Attachment 1 – Project Description and Design Change Location Map

1. 2019 REEVALUATION

1.2 Proposed Design Changes

OAK HILL PARKWAY

Design Change Location Map

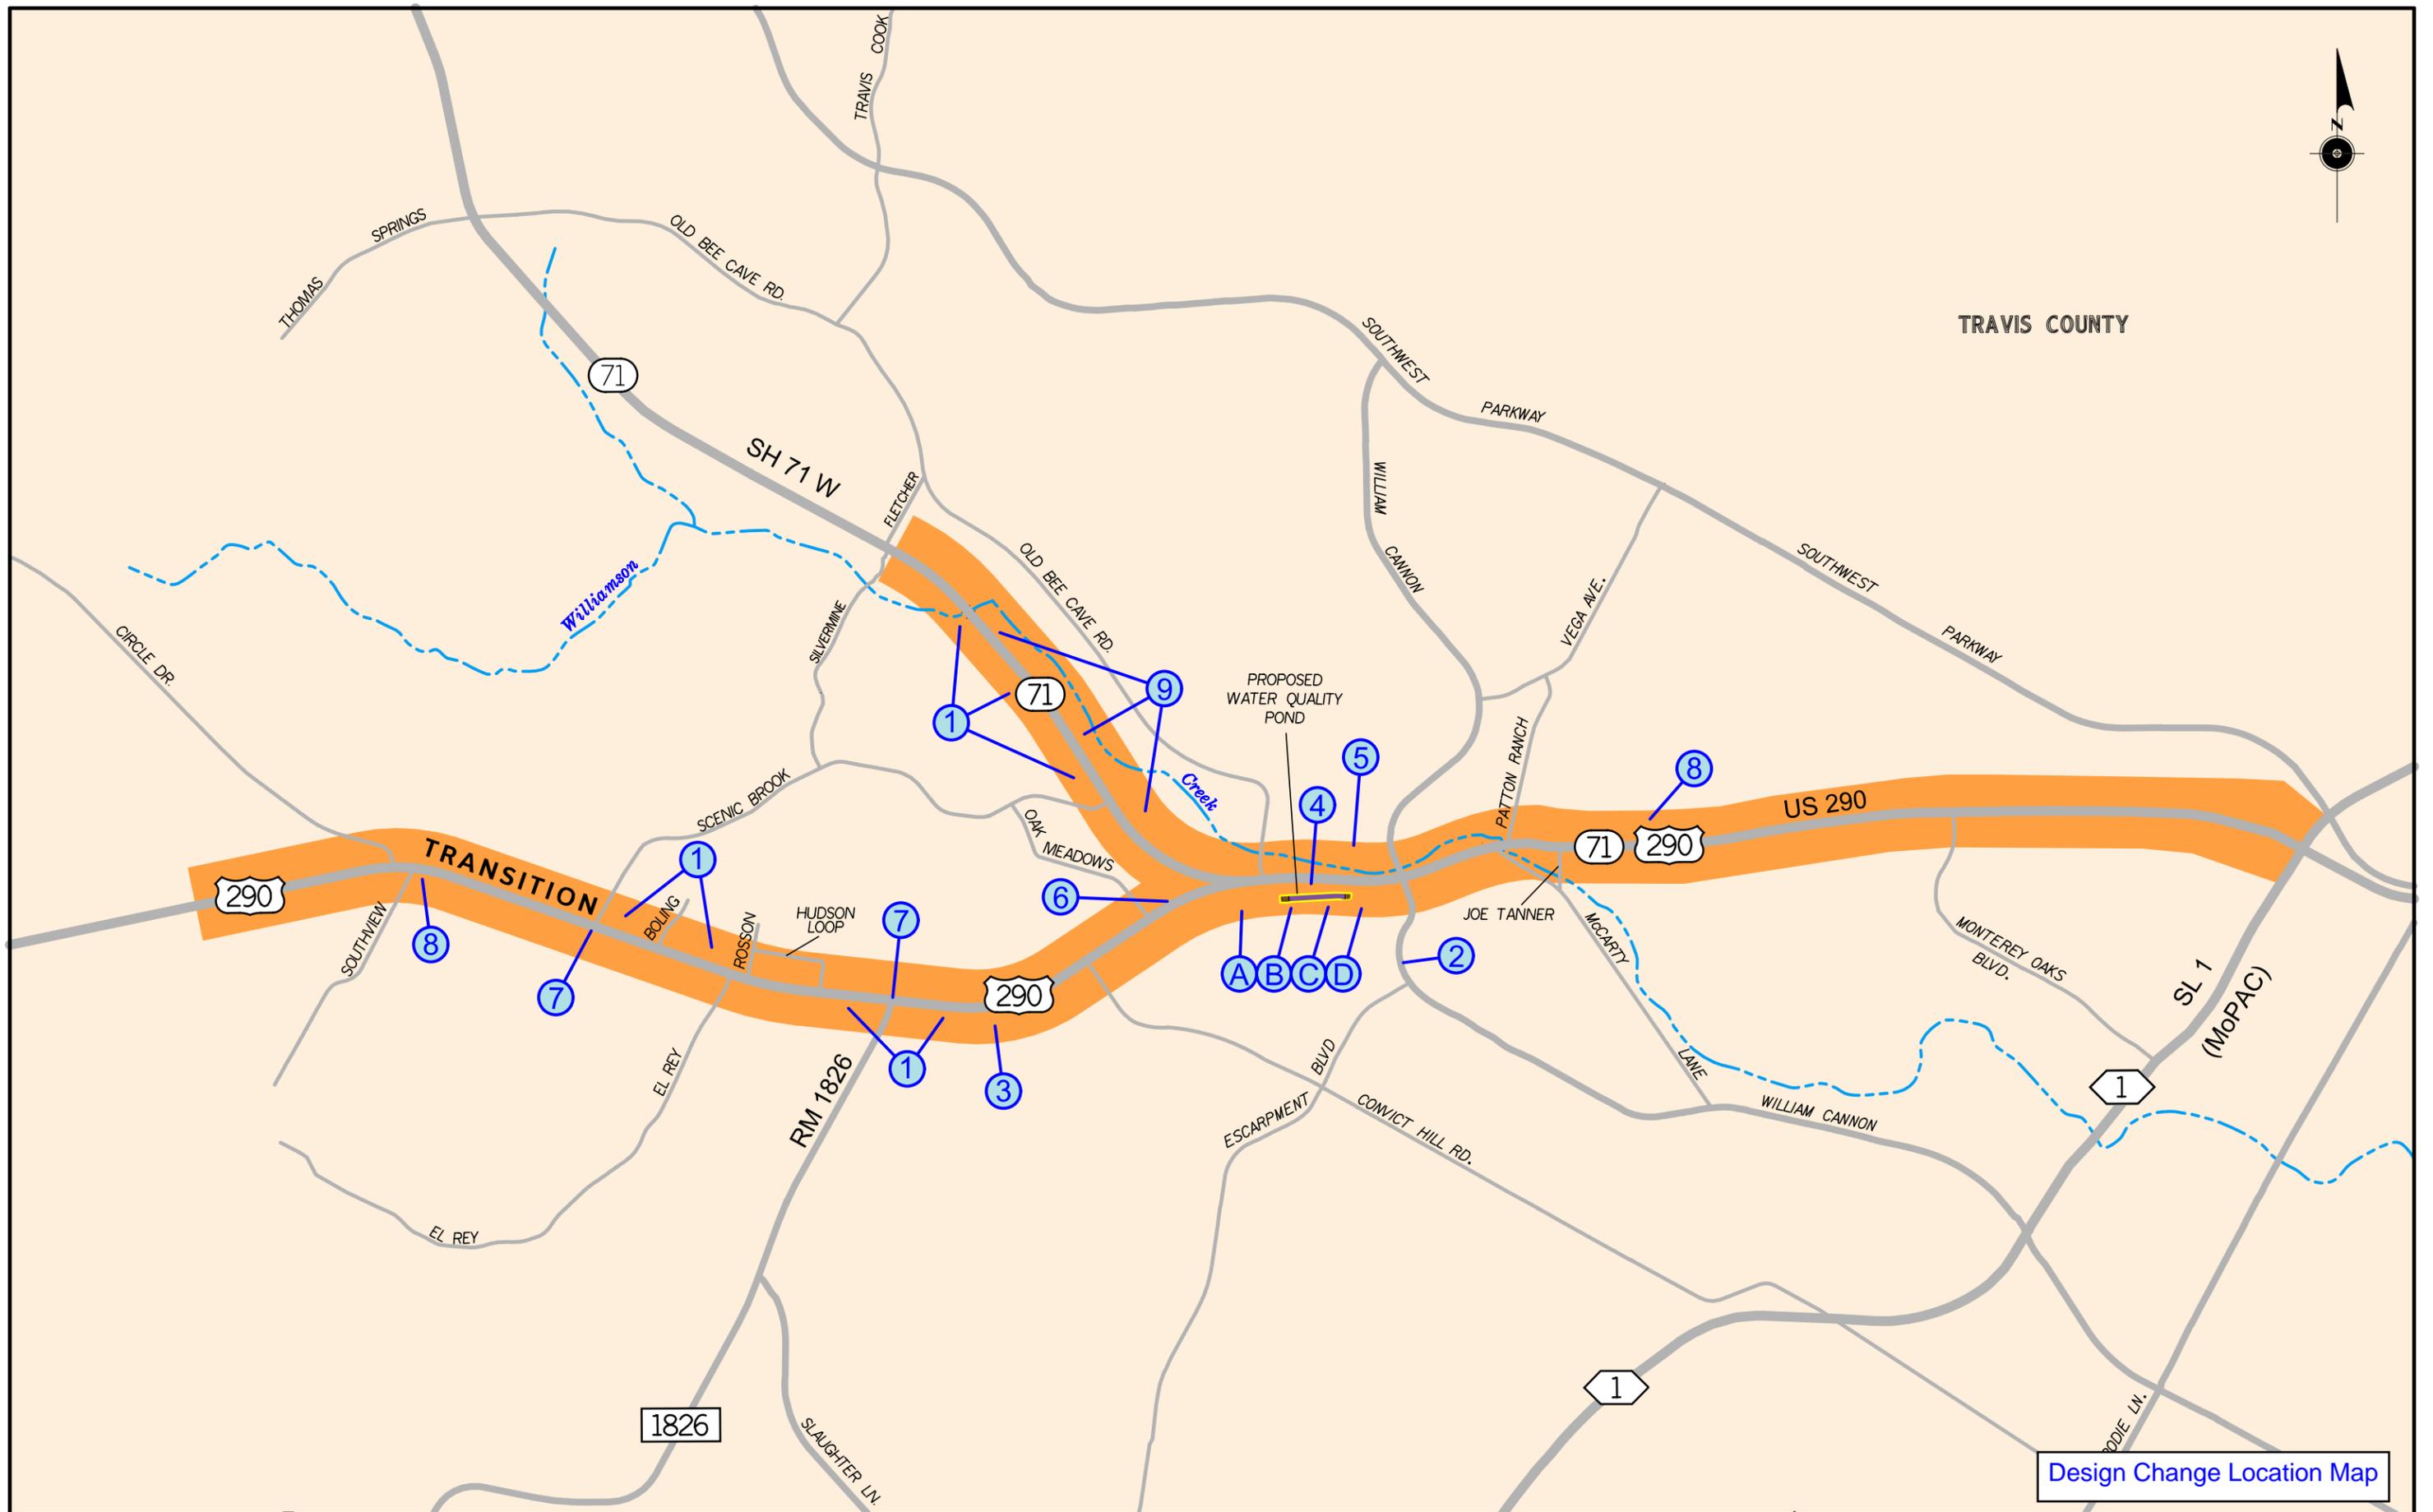
1. Right of way (ROW) requirements have changed to reflect utility relocations along westbound US 290 between Scenic Brook Drive and Boling Drive; between Hudson Loop and Oak Meadow Drive; and on eastbound US 290 between Hill Oaks Drive and Williamson Creek.
2. Revised William Cannon to 11' lanes with modified width SUP along both sides south of US 290 mainlanes.
3. Revised eastbound frontage road alignment from RM 1826 to Convict Hill to provide more separation from existing ROW and eliminated need for braided eastbound entrance ramp from RM 1826.
4. Removed driveways along the south side of US 290 from Hill Oaks Drive to Williamson Creek, due to grading, existing driveway access, and utility relocations.
5. Realigned SUP west of William Cannon, further from protected trees.

6. Shifted US 290 westbound entrance ramp from SH 71 further west from proposed intersection to improve safety and operations.
7. Provided future connection at both RM 1826 (north side) and Scenic Brook Drive (south side) intersections.
8. Traffic projections were revised to reflect non-tolled design, which allows for two-lane ramps to be redesigned as one-lane ramps at eastbound exit ramp to Scenic Brook Drive and westbound exit ramp to William Cannon Drive.

9. SH 71 mainlanes, frontage roads and ramps moved south for utility acquisitions between approximately Fletcher Lane and US 290. SUP replaced the sidewalks on north side of the westbound frontage road in this area.
